CONTRACT NO. 60F72

PROPOSED
HIGHWAY PLANS

O.R. ROUTE 0003 (ALGONQUIN BYPASS)
SECTION 18A-2
ILLINOIS ROUTE 31 (N. JCT) TO ILLINOIS ROUTE 31 (S. JCT)

ADDENDUM A REV. 5/21/2012 CTB

O.R. RTE.	SECTION	COUNTY	TOTAL SHEETS	SHEET NO.
0003	18A-2	MCHENRY	825	355
CONTRACT NO. 60F72				
FED. ROAD DIST. NO. 1 ILLINOIS FED. AID PROJECT

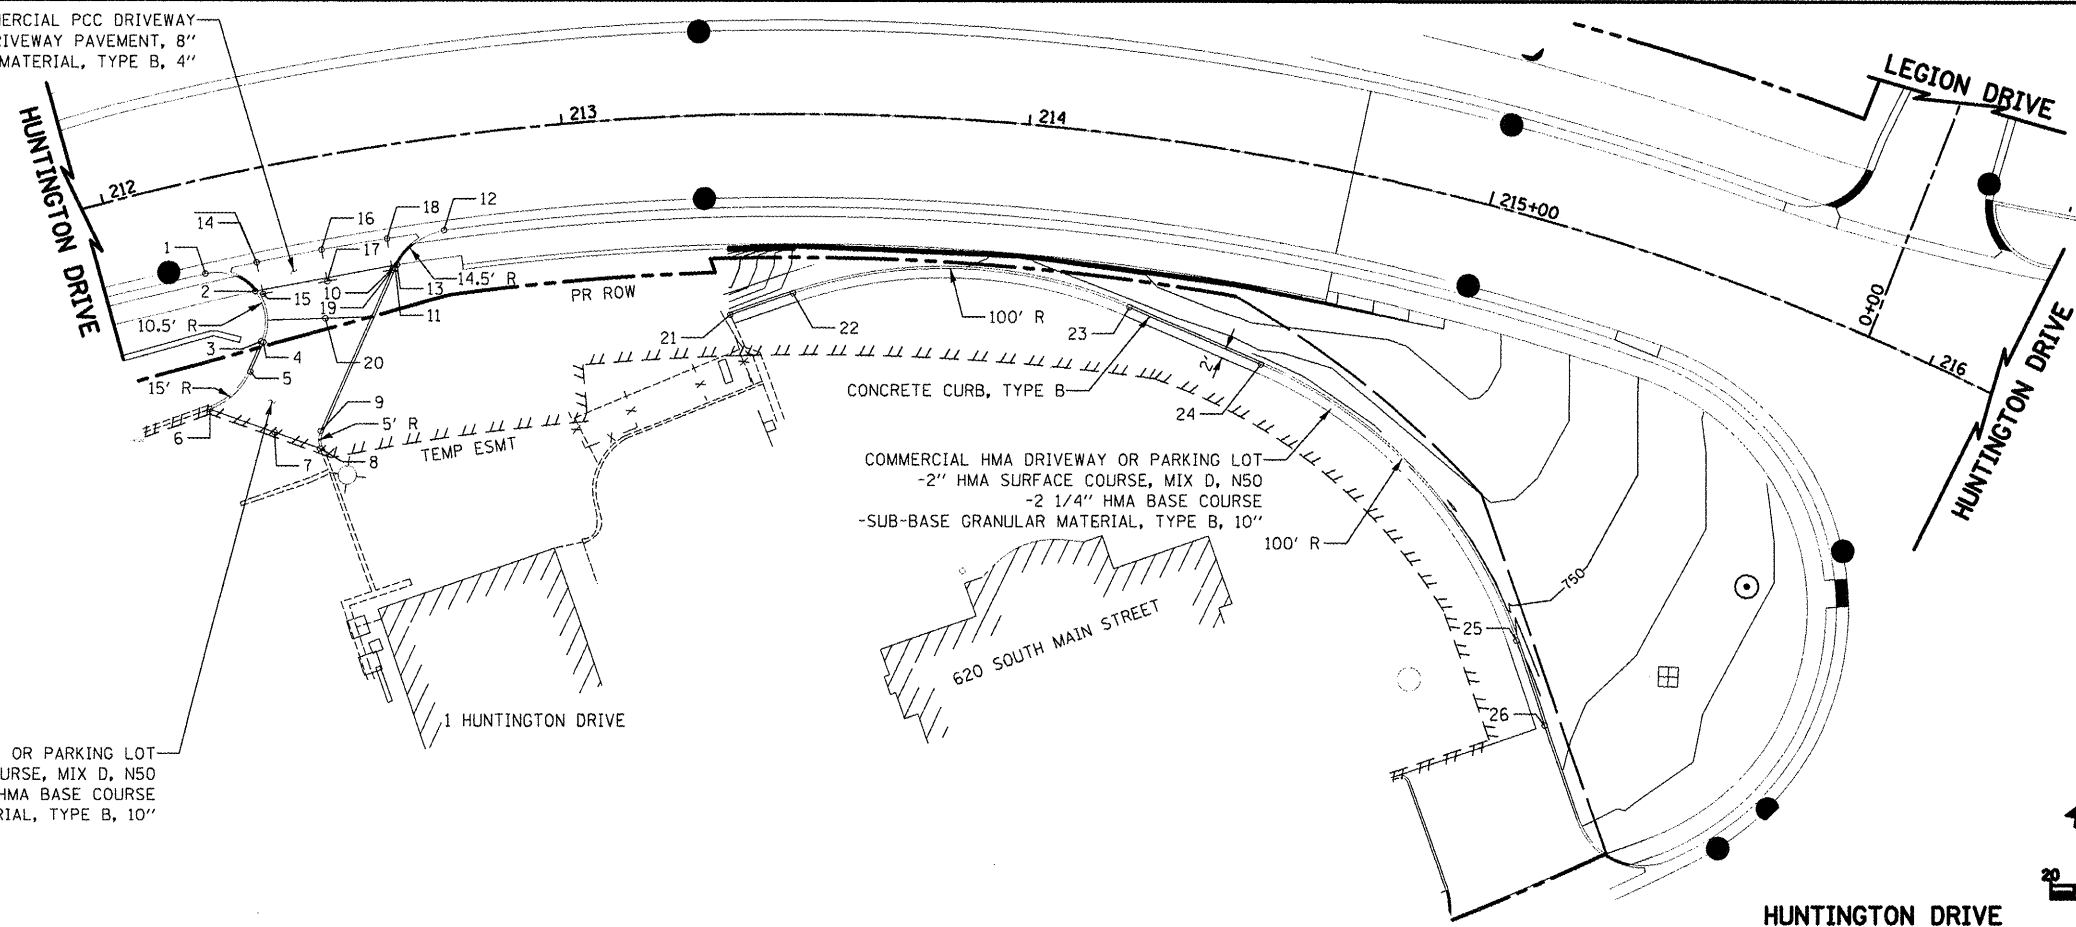
△ DETAIL REPLACED BY DETAIL SHEETS 355A, 355B, AND 355C
